CITY OF PORTLAND, MAINE

Project Name: **Subdivision of second floor into 5 apartments**
Project ID: #2014-103 CBL: 129 - L002001
Address: 671 Forest Avenue
Applicant: United USA LLC
Planner: Jean Fraser

PLANNING BOARD REPORT PORTLAND, MAINE

Submitted to: Portland Planning Board Public Hearing Date: August 12, 2014	Prepared by: Jean Fraser, Planner Date: August 8, 2014
--	--

PLAN OF Subdivision Plan		Portland, Maine
MADE FOR United USA LLC		
689 Forest Avenue	DATE: May 7, 2014	SCALE: 1" = 10'
BOOK #879	TITUMB ASSOCIATES	
687/879/2/03/03/03	03719743188 www.titumb.com	
FILE #8794

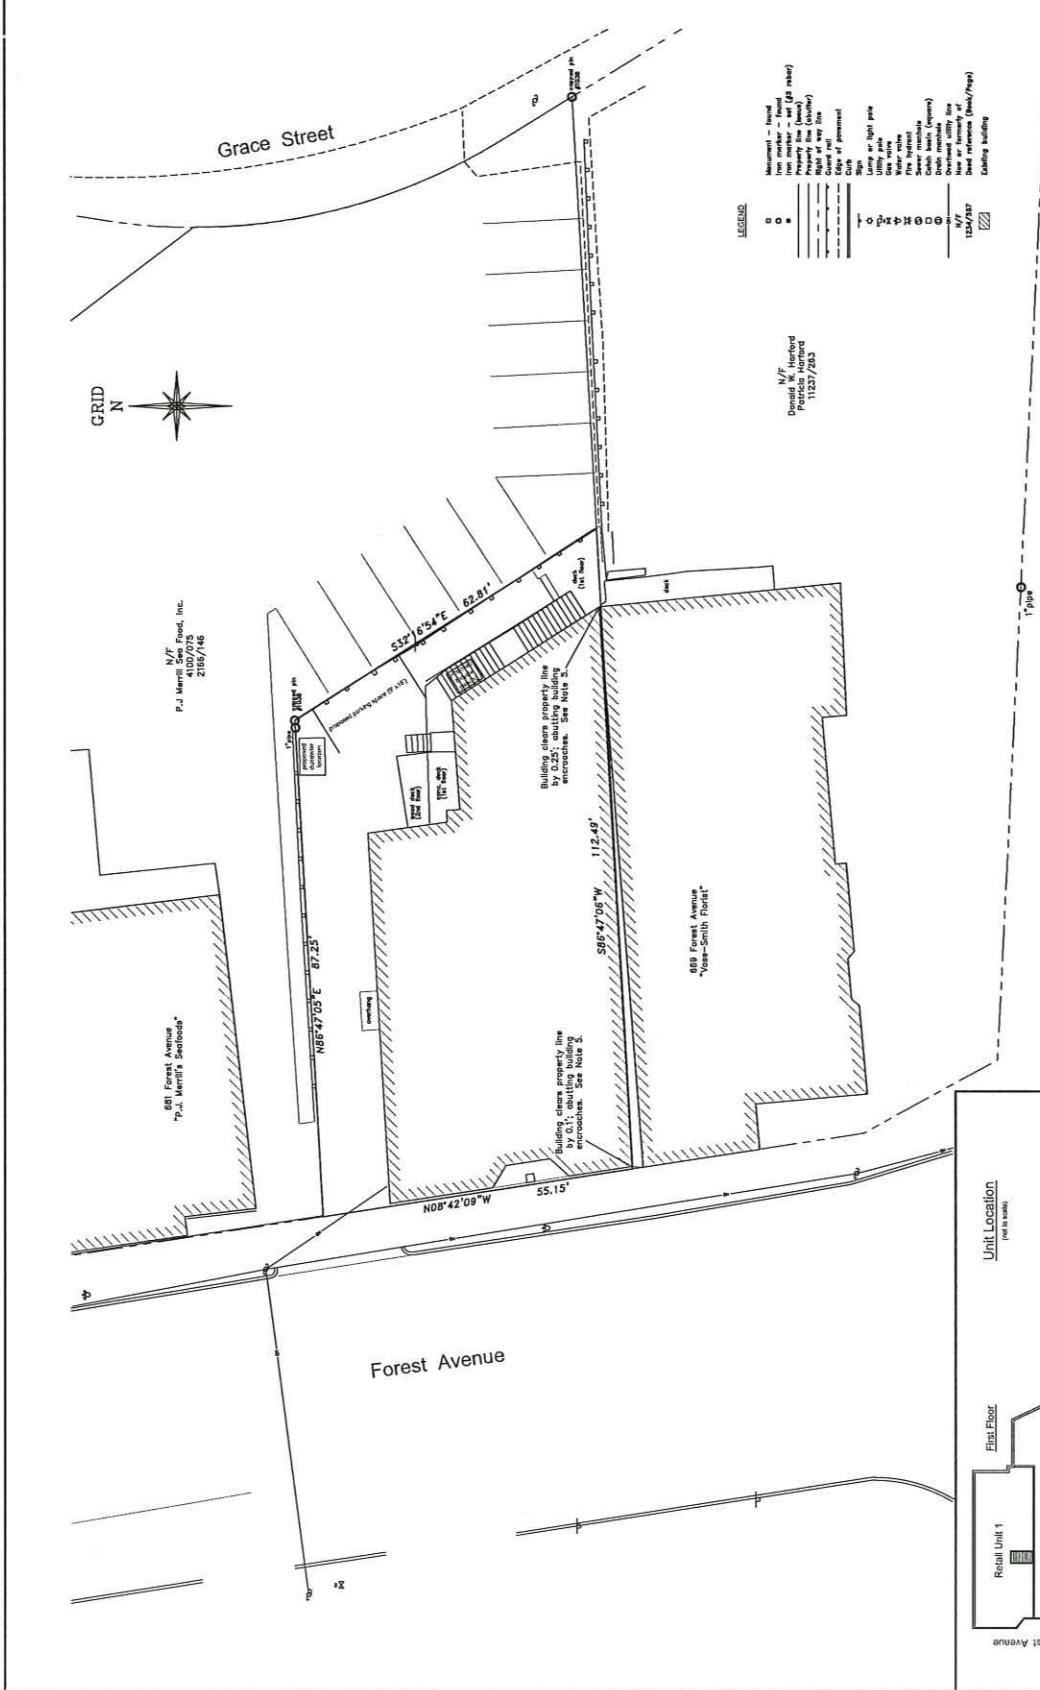
The subdivision plat has been reviewed by staff. The plat will need to show the zoning information for the zone and mention that historic district the parcel is in. The plat will also need to show the uses of the building, the number of residential units (existing and proposed), and the number of parking spaces on site.

6. **Subdivision Plat:** The Plan in P2 is both a Site Plan and Subdivision Plat. The first suggested subdivision condition requires some further revisions to the Plan so it can be signed as a Plat, and the revision would include a note regarding the parking lease for the 4 parking spaces to meet the zoning requirement.

A recommended condition of approval calls for a revised plat be submitted for review by the Planning Authority and signature of the Planning Board.

EXTERIOR ELEVATION

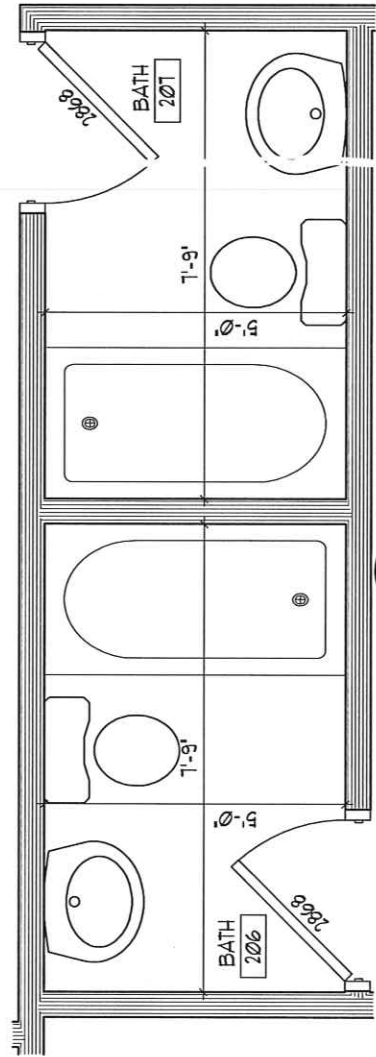
Confirmed as
approved but
needs rear
enclosure too.
